A D D E N D U M N O . 4

ROOF REPLACEMENT AND RELATED WORK HILLSIDE INTERMEDIATE SCHOOL

Naugatuck, CT
KBA #15037.00

Date: February 12, 2016

RFI #008

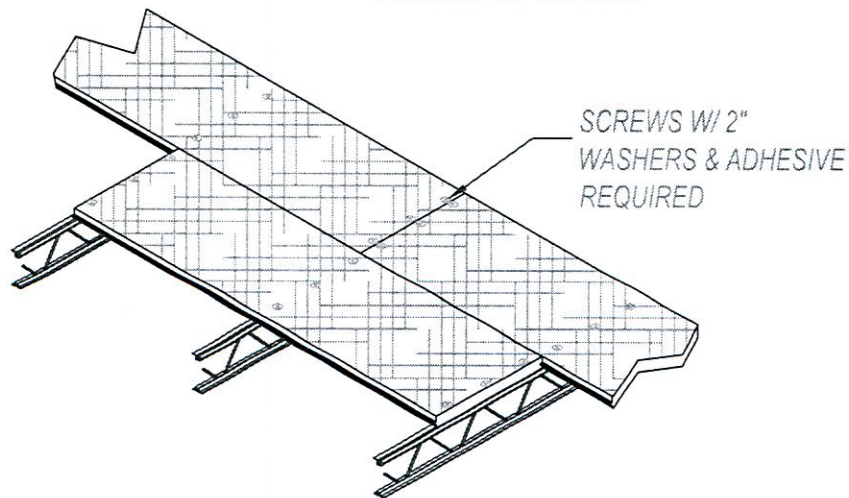
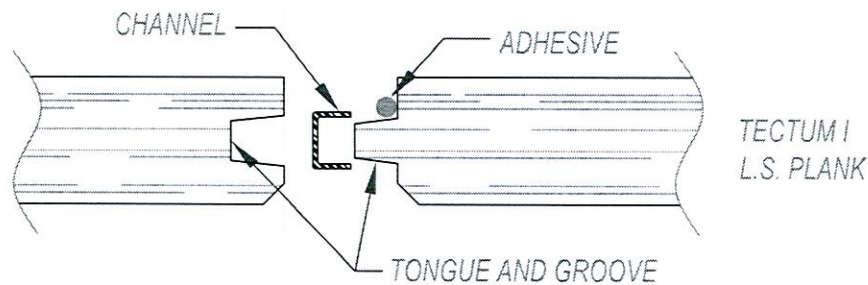
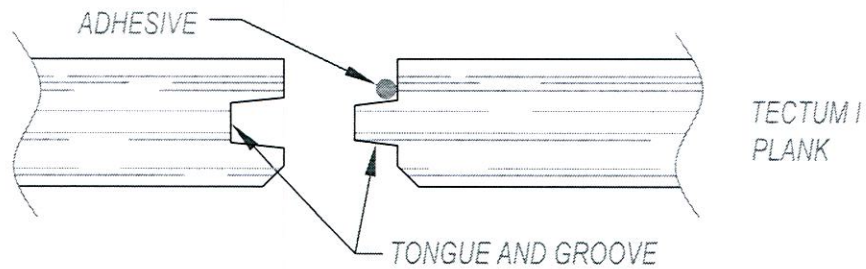
Richard,
I'm looking into it but I'm not finding anybody that has Bulb Tee's, I don't think you can get them anymore?? What do you want us to do?

Infill voids with Tectum "Plank" panels in lieu of Bulb Tees. See attached.

SKA2.02

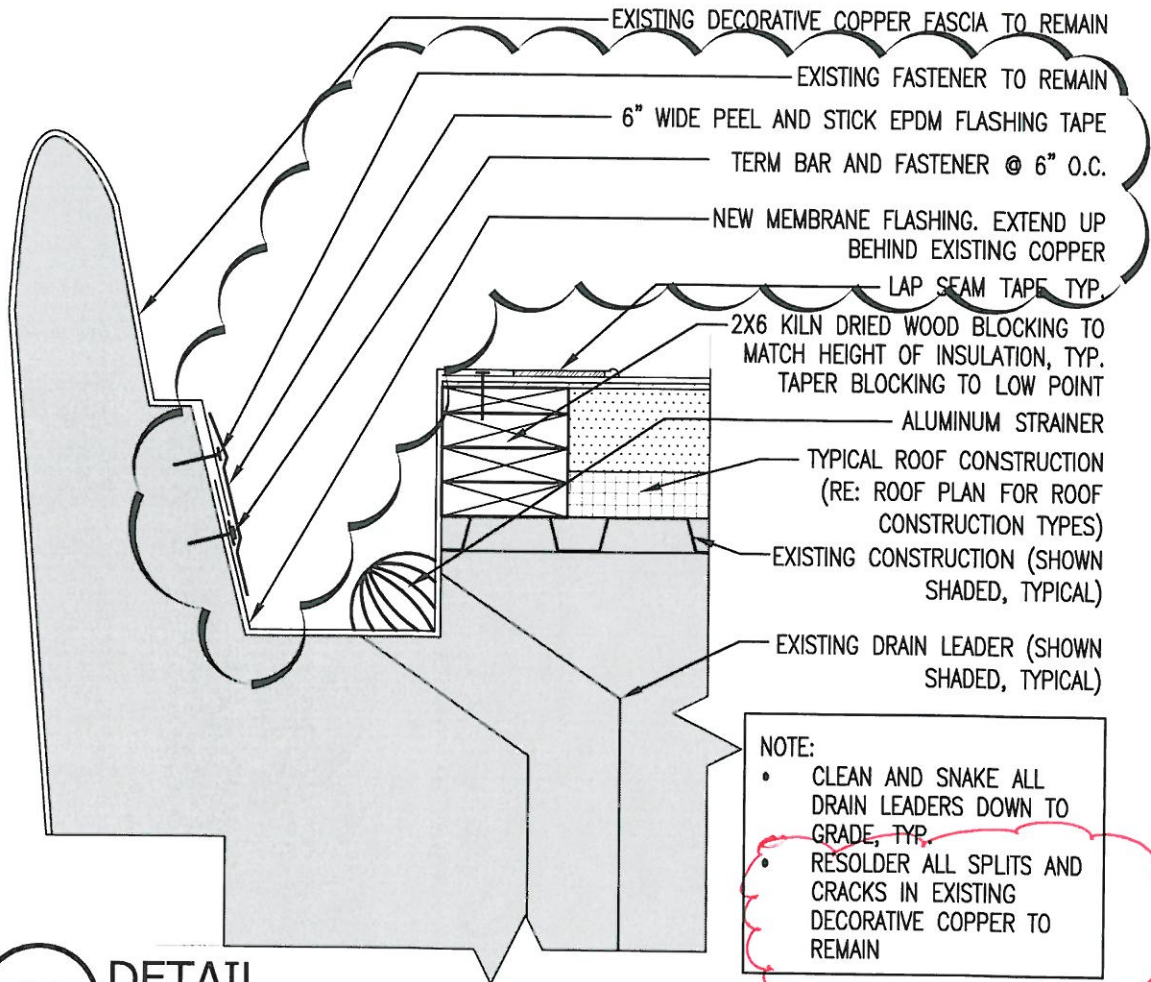
Upon review of SKA2.02, the Soldering of the Existing Copper Decorative Fascia for splits and cracks is a very difficult item to price out. I may see more of less work than the other bidders. Can I suggest and Allowance of say \$10,000 with a unit price per lf for add or deduct.

CAN YOU QUANTIFY W/ VF OF
SOLDERING OR AN ALLOWANCE.
TUFF TO FIGURE ACTUAL WORK PER
WITHOUT EXAMINATION OF EVERY
INCH OF METAL

F. Allowance No. 6: Cost to re-solder 50 sections of split or cracked sections of copper fascia on original 3-story building.

7. Re-solder One (1) Split or Cracked section of Copper Fascia:

- a. Description: Re-solder one (1) split or cracked section of copper fascia on original three-story building.
- b. Unit of Measurement: Each

See Addendum No. 4.
